APPLICATION NO.	FILING DATE	FIRST NAMED INVENTOR	ATTORNEY DOCKET NO.	CONFIRMATION NO.
09/603,409	06/26/2000	Dirk V. Hoyns	B0762/7001	3130

Office Action Summary	Application No.	Applicant(s)
	09/603,409	HOYNS, DIRK V.
	Examiner (Jackie) Tan-Uy n T. Ho	Art Unit 3731

DETAILED ACTION

ATTACHMENT I

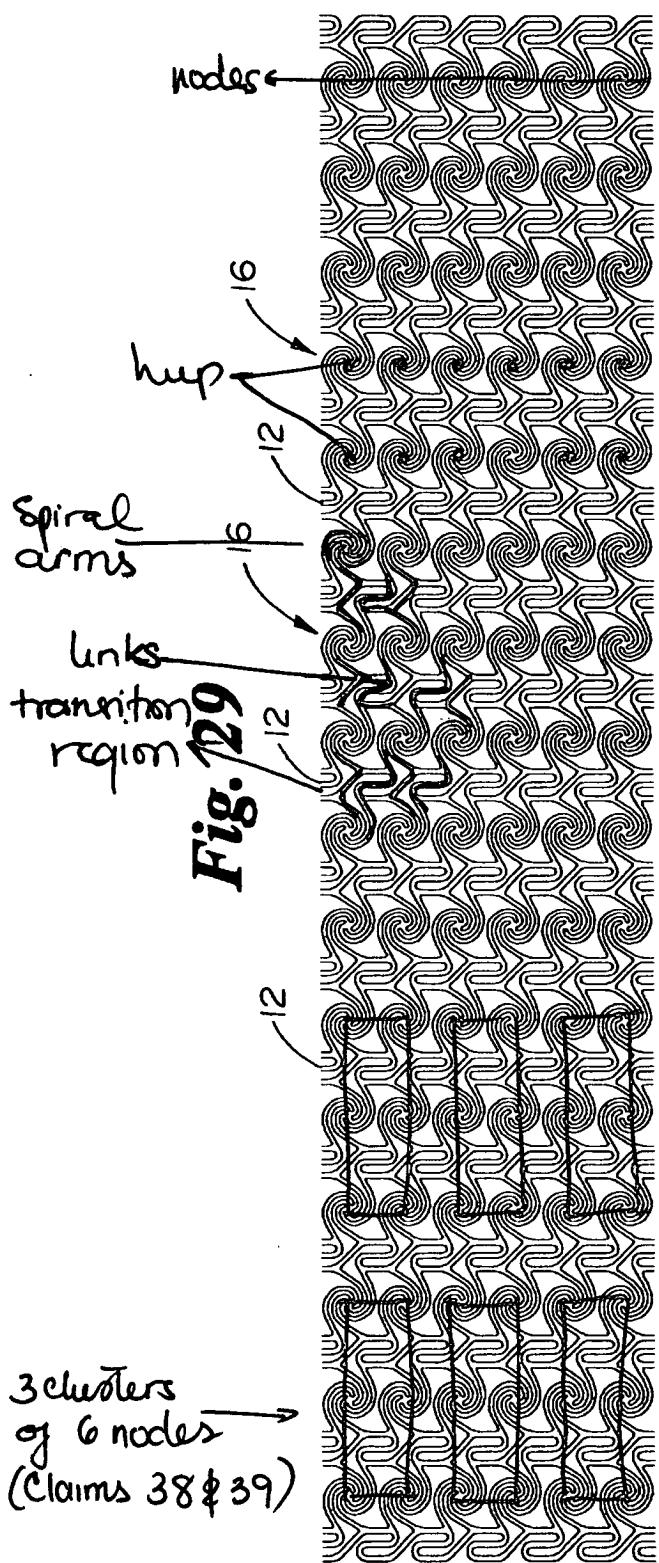
Ehr et al. disclose a stent including: (See attachment I)

- A plurality of nodes
- A central hub for each node
- At least three arms extending from the hub
- A transition region where each arm being connected to an arm of an adjacent node
- A link between the nodes being defined by the connected arms of the adjacent nodes

- The arms in the links of adjacent nodes curve in opposite directions
- The links are S-shaped

- The arms of the nodes are arranged generally to define a spiral

- A gap between adjacent arms of a spiral is of substantially constant width up to the transition region
- Each of the arms of a node is connected at a root to the hub of the node
- Each arms of each node is connected to a different one of the adjacent nodes

- A plurality of adjacent pairs of nodes lie along radially extending planes and the planes being spaced along the length of the stent
- The links between nodes of the pairs lie along the radial planes and extend in a circumferential direction
- Additional pairs of adjacent nodes extending along a row that extends generally helically along the stent

- The transition region is disposed at the mid-portion of the link
- The stent is formed from stainless steel
- The stent having a low profile and expanded diameters adapted to be deployed within a human biliary duct, blood vessel, urological passage (inherent)

- The nodes are arranged in clusters of six nodes each

- The arms of the nodes are arranged generally to define a spiral
- The nodes arranged in a plurality of helical row, the nodes in each row being serially connected to each other by a link

- A plurality of nodes
- S-shaped links connecting adjacent nodes
- A central hub for each node
- Three arms extending from the hub

- The nodes being arranged in clusters of six in which two arms of each node are connected to nodes of a cluster and one arm of each of the nodes in that cluster is connected to a node of another cluster.
- Each of the nodes in the stent is shared by three adjacent clusters

In regard to claims 1-38

3 clusters
of 6 nodes
(Claims 38 & 39)
